Subject: **Response to Portion of NRC Request for Additional Information
Letter No. 67 Related to ESBWR Design Certification Application –
DCD Section 3.9 – RAI Numbers 3.9-4 through 3.9-11, 3.9-17, 3.9-18,
3.9-23, 3.9-26, 3.9-27, 3.9-29, 3.9-32, 3.9-34 through 3.9-36, 3.9-38
through 3.9-40, 3.9-44, 3.9-46 through 3.9-55, 3.9-57, 3.9-59, 3.9-60,
3.9-67, 3.9-72 through 3.9-76, 3.9-79, 3.9-80, 3.9-91 through 3.9-94,
3.9-96 through 3.9-99, 3.9-101, 3.9-102, 3.9-104, 3.9-105, 3.9-108, 3.9-
110, 3.9-132, 3.9-140, 3.9-142, 3.9-147, 3.9-150, 3.9-151, and 3.9-153**

Enclosure 1

MFN 06-464

DCD Section 3.9

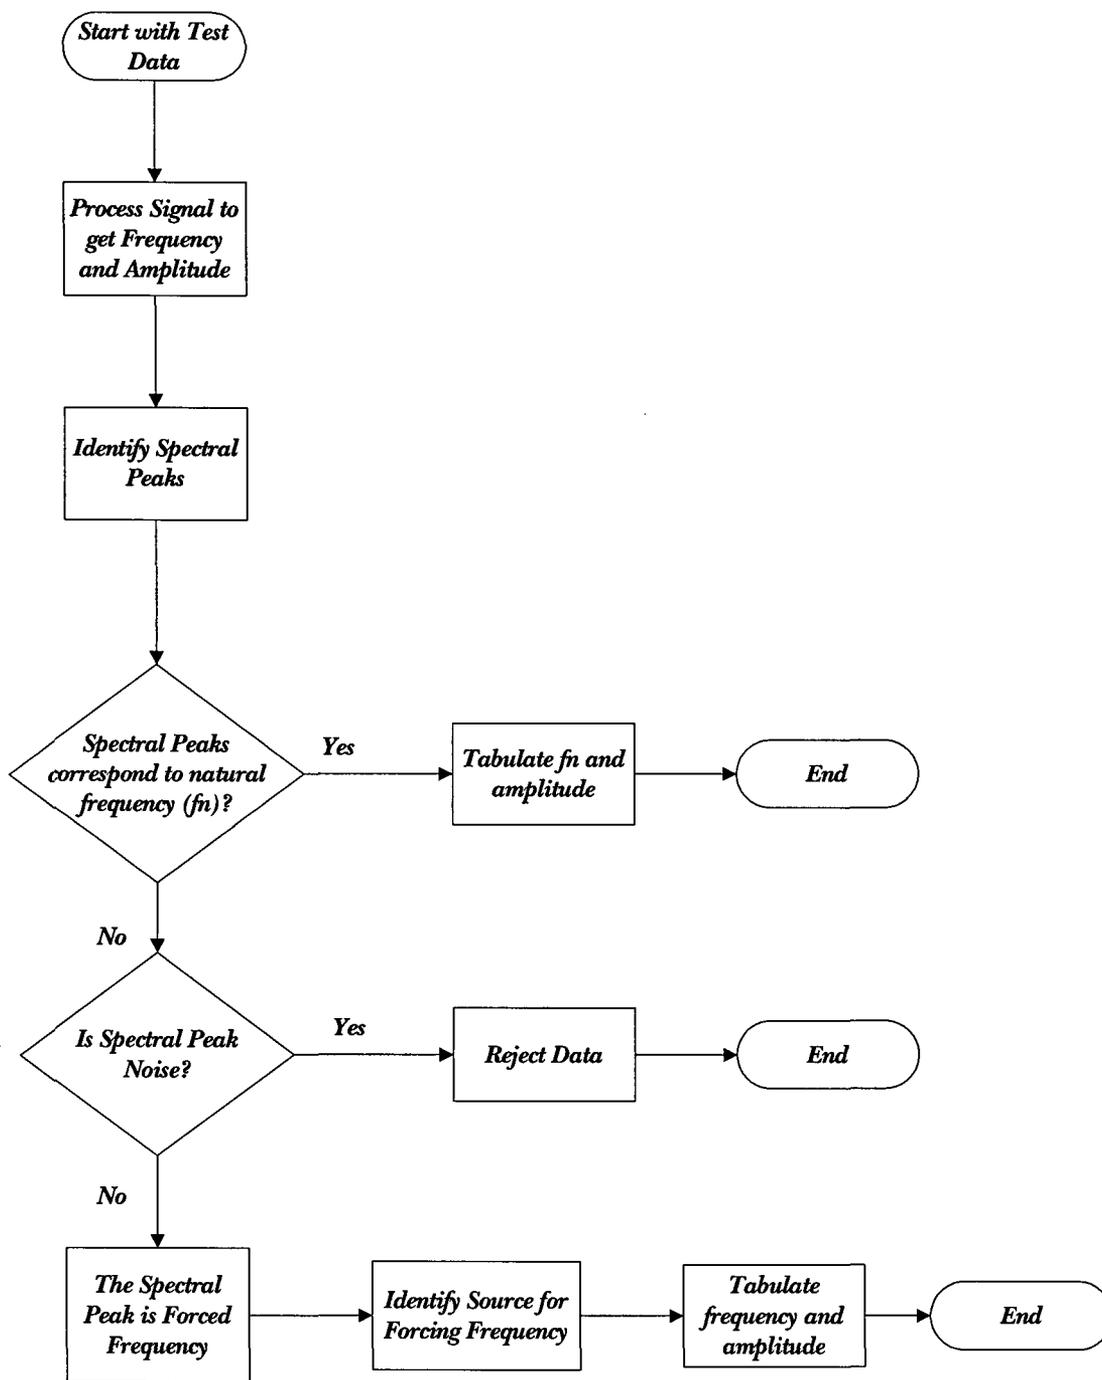
It is stated in DCD Tier 2, Section 3.9.2.3 that special analysis of the response signals measured from reactor internals of many similar designs is performed to obtain the parameters, which determine the amplitude and modal contributions in the vibration responses. Identify the specific parameters which are used to determine amplitude and modal contributions and explain with typical diagrams how these parameters are used in the special analysis.

The modal amplitudes and the forced response amplitudes are then used to calculate the expected ESBWR amplitudes for the same component. These ESBWR expected amplitudes are determined by calculating the expected changes in the forcing function magnitudes from the test component to the ESBWR component. For example, for flow turbulence excited components, the magnitudes are determined by ratioing with the flow velocity squared.

A flow chart of the above process is shown below.
